Service Bulletin

Category N	Applicable Models 1988-92 626/MX-6	Subject RATTLING NOISE FROM THE POWER STEERING RESERVOIR	Bulletin No. 003/93 Issued 11/5/93 Revised
---------------	---------------------------------------	--	--

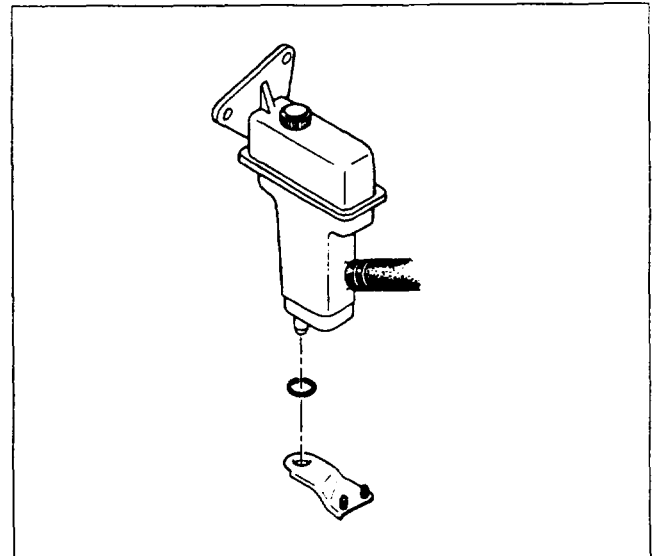
A rattling noise heard from the front passenger side of the vehicle may be caused by the power steering reservoir mounting pin and the lower mounting bracket locator hole. The noise is difficult to duplicate and is most evident during cold engine starts.

1. Verify that the complaint is not coming from another part of the vehicle.
2. Remove the 2 mounting bolts from the bottom of the power steering reservoir.
3. Lift the reservoir to access the lower mounting bracket.
NOTE: When raising the reservoir, take care not to spill the power steering fluid on painted surfaces. If fluid does spill, clean up immediately.
4. Insert grommet into the locator hole in the lower mounting bracket.
5. Lubricate the grommet to facilitate installation of the locator pin on the reservoir.
6. Install the two mounting bracket bolts.

Part Number	Description
G211 32 425	Rubber Grommet
